Green Infrastructure & Biodiversity Statement

Revision 2 — Response to Local Planning Authority Comments

Project: Smart Electrical Systems, Goat Mill Road, Dowlais, Merthyr Tydfil, CF48 3TD

3. Boundary Treatment — Fencing & Security

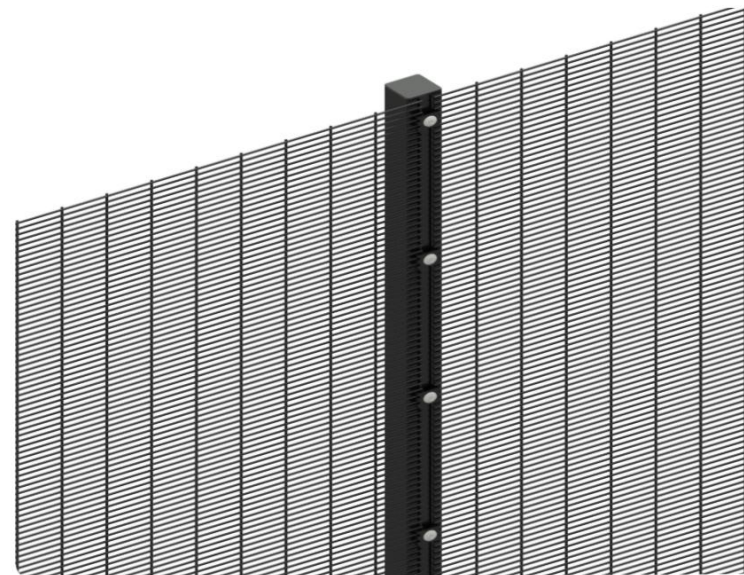
LPA Comment	Response / Revision
Boundary fencing: height, design, solid appearance, discordant with estate character; unclear justification for enclosing front car park	1.8m black anti-climb 358 mesh fencing proposed, set behind the retained front hedgerow. Fencing runs along the southern boundary and around the front car park; enclosure of the car park is retained and justified on security grounds (Section 3).
Trees removed at front of site — not shown on drawings or addressed in the GIS	Now addressed in Section 4. Replacement planting proposed at a minimum 3:1 ratio in accordance with PPW Edition 12.
Hedge replacement ratio (3:1); replacement shown over existing hedge; no species comparison; no long-term management plan	Access arrangement revised — the boundary hedgerow is now retained in full; no hedgerow removal is proposed (Section 5). A long-term establishment and management plan is provided (Section 8).

- 1.8m high, black, 358 anti-climb weld mesh security fencing is proposed (product ref. CLA-MSH-358-KIT-1830-2530-DIG-BLK, dig-in posts).
- The fence is positioned behind the retained front hedgerow, maintaining boundary continuity and softening its visual impact when viewed from the highway.
- Fencing runs along the southern boundary and around the front car parking area.

- The unit accommodates high-value electrical equipment and stock. Secure enclosure of the car parking and loading area is required to mitigate the risk of theft and unauthorised access to these assets.

7. Wildflower & Pollinator Margins

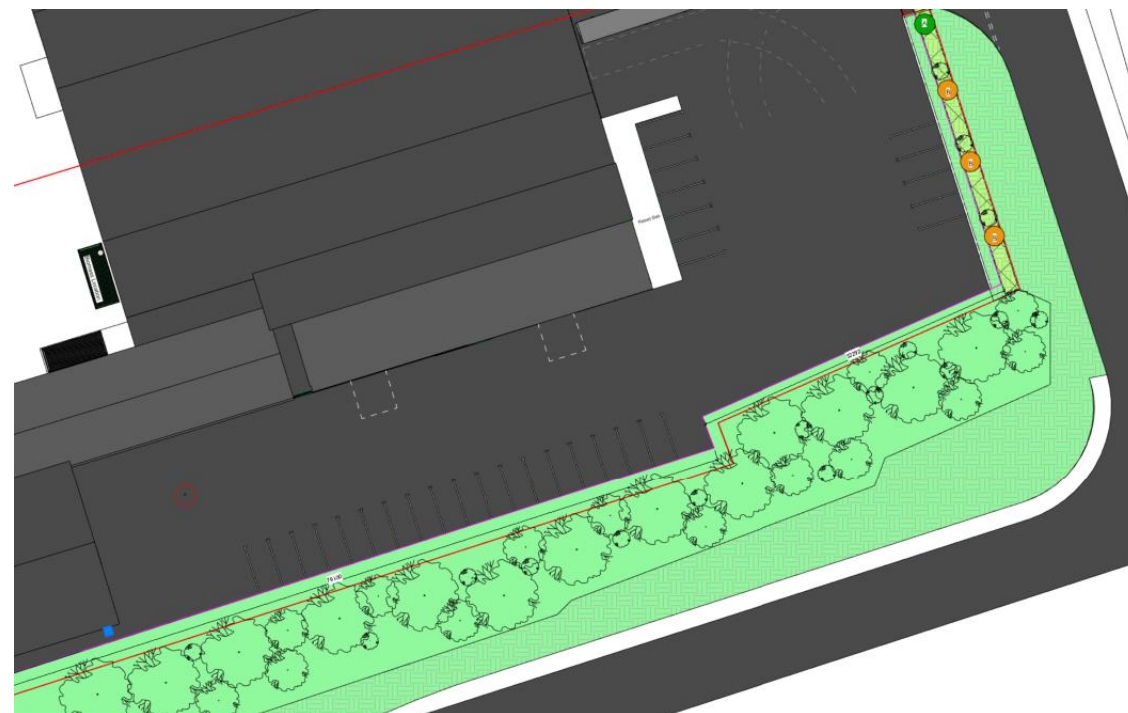
Wildflower and tussocky grass margins referenced but not shown on plan; no species mix or management plan	Margins now shown on the site plan within the landscaped buffer. Species mix provided in Section 7; establishment and management plan provided in Section 8.

- Native wildflower and tussocky grass margins will be established within the landscaped buffer areas shown on the site plan (southern boundary and around the car park perimeter).
- Proposed general-purpose native wildflower and grass seed mix, selected for pollinator value:

- Margins to be cut once per year (late summer/autumn, after flowering and seed-set), with arisings removed to maintain low fertility and species diversity.
